Office of General Services

ADDENDUM NO. 2 TO PROJECT NO. 47676

CONSTRUCTION WORK FUEL TANK MODIFICATION & ENVIRONMENTAL REMEDIATION – WESTERN REGION SERVICE CONTRACT GNARESP CORNING TOWER ALBANY, NY 12242

May 27, 2025

MARK	DATE	DESCRIPTION
	5/22/2025	ADDENDUM NO. 2
	1/31/2025	FINAL SUBMISSION
PROJECT NUMBER:	47676	- C
DESIGNED BY:	M. GUTMANN	
DRAWN BY:	A. KELLY	
FIELD CHECK:	M. WESOLOWSKI	
APPROVED:	M. WESOLOWSKI	
SHEET TITLE:	ABOVEGROUND FUEL STORAGE TANK SINGLE AND DUAL HOSE DISPENSER AND ISLAND DETAILS

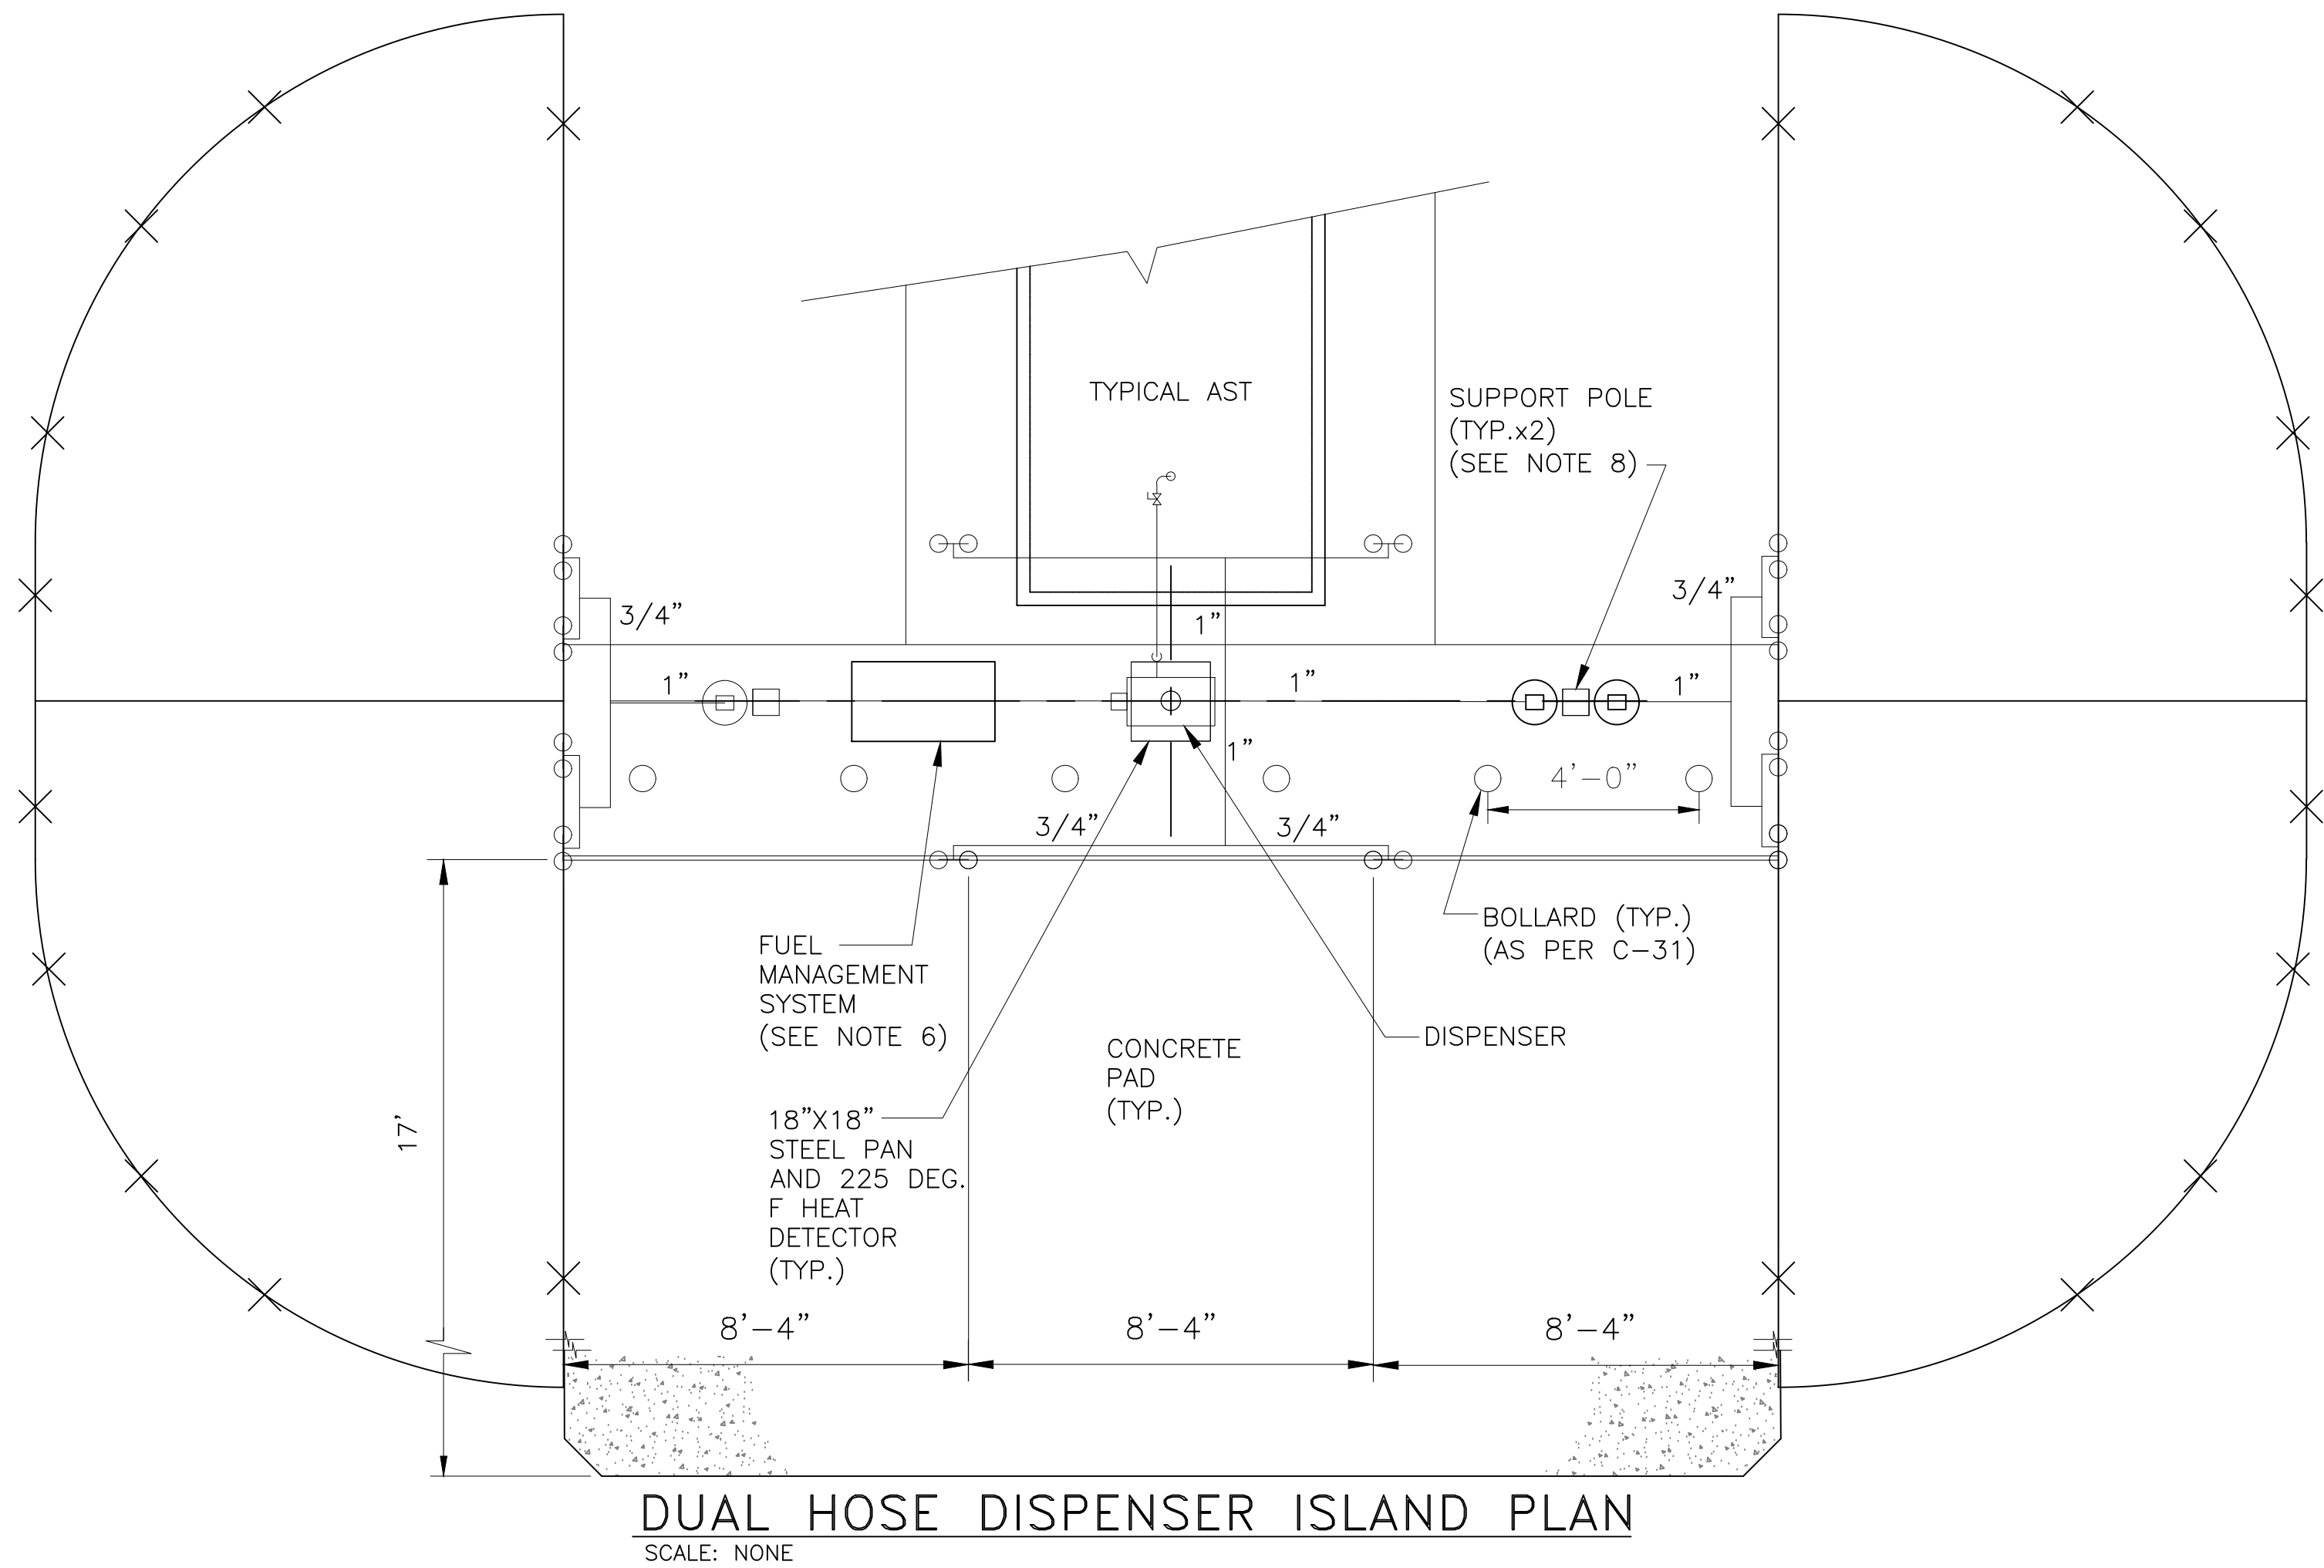
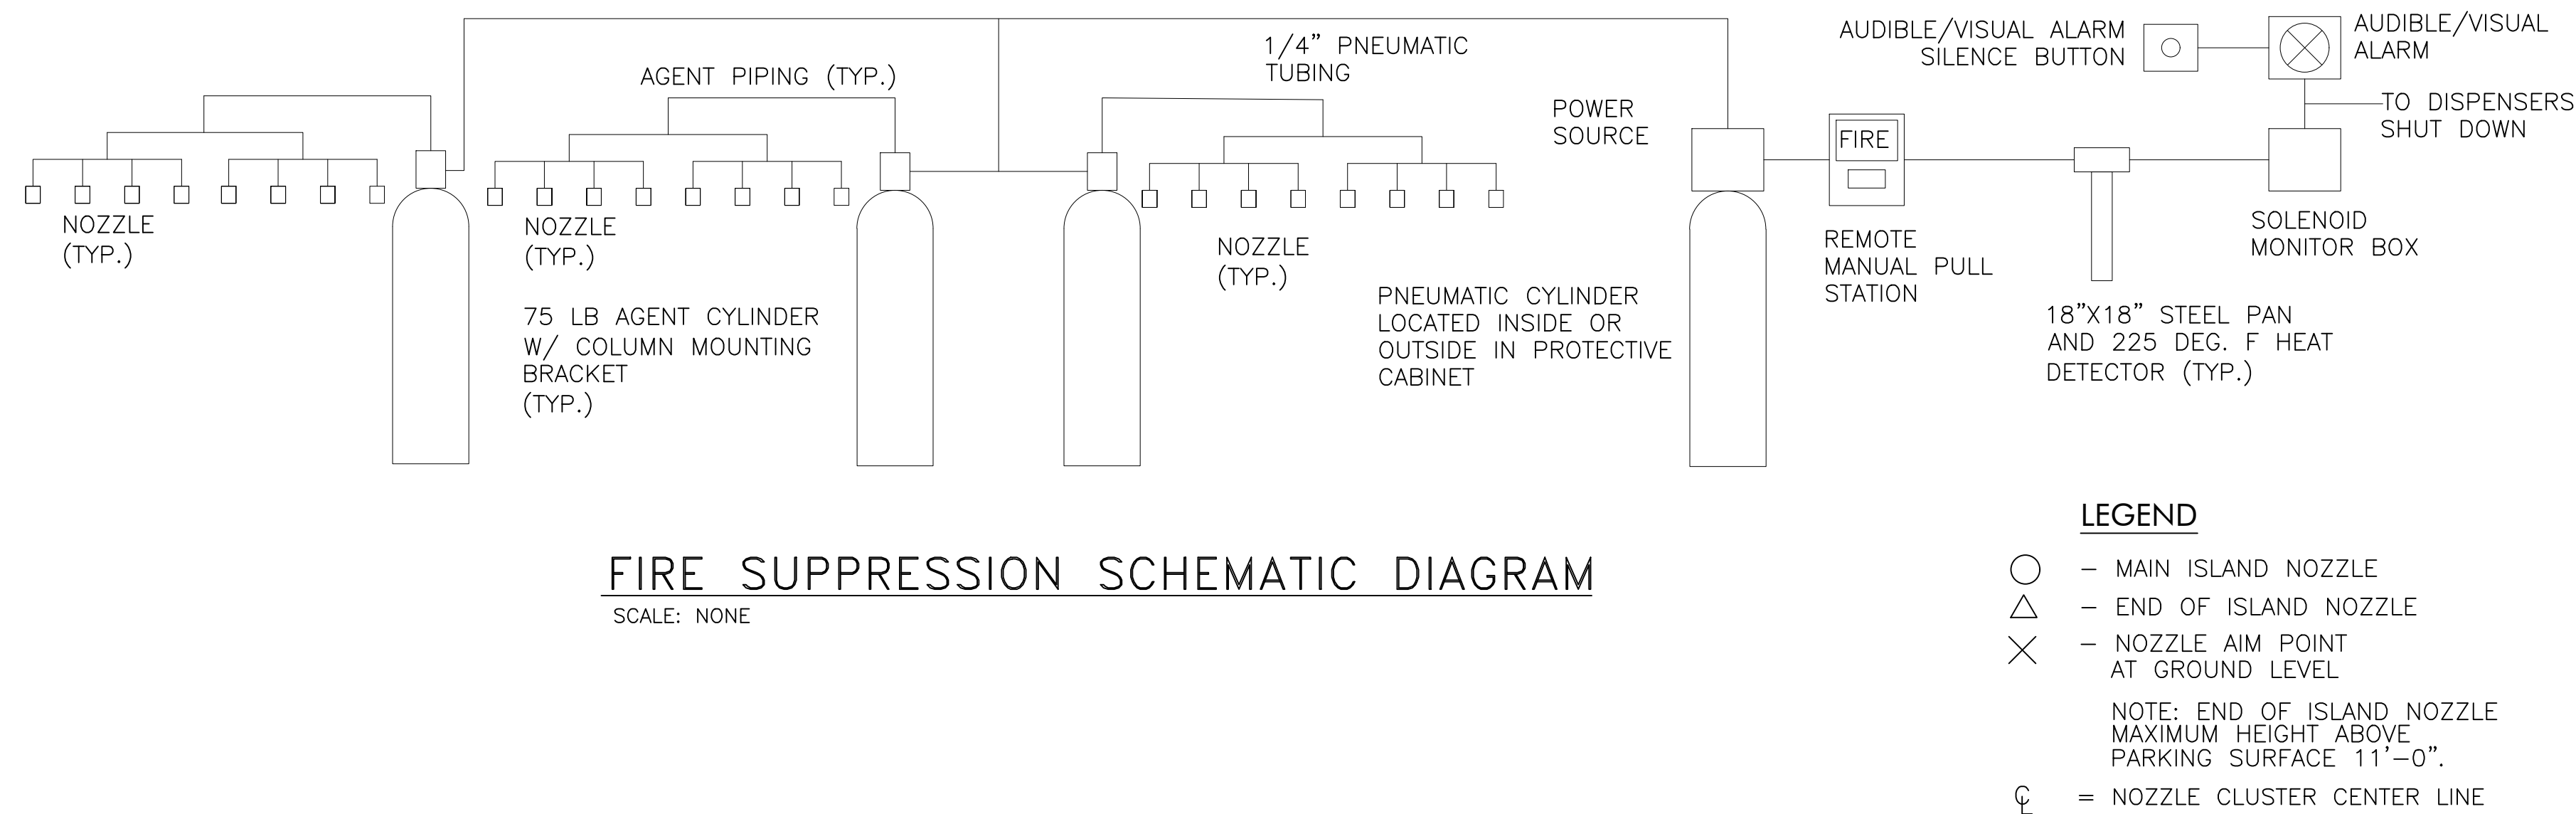
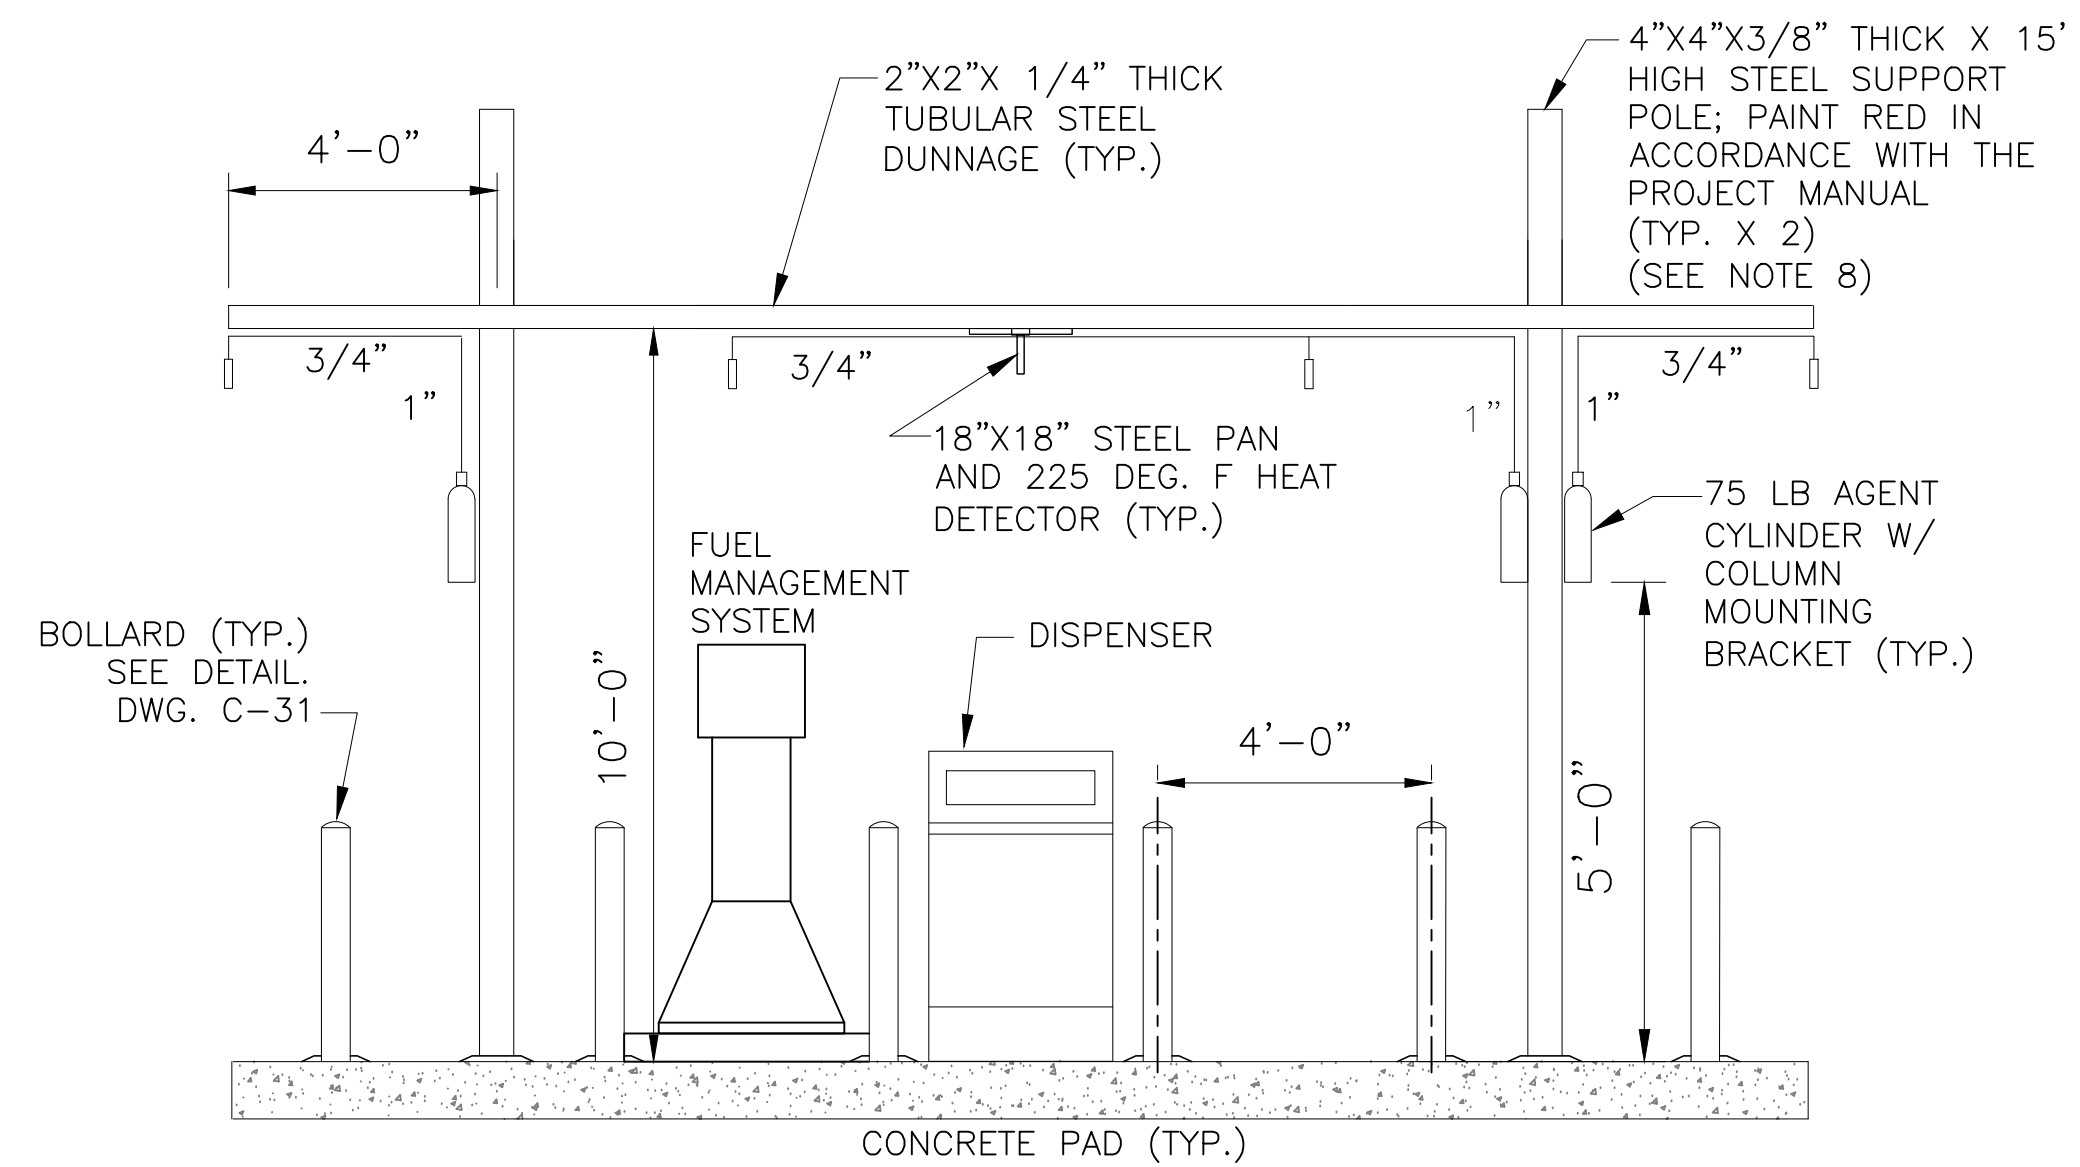
2. Revised Drawings:
 - a. Drawing Nos. C-23, C-24, and C-25, noted “ADDENDUM NO. 2 5/22/2025” accompany this Addendum and supersede the same numbered originally issued drawings.
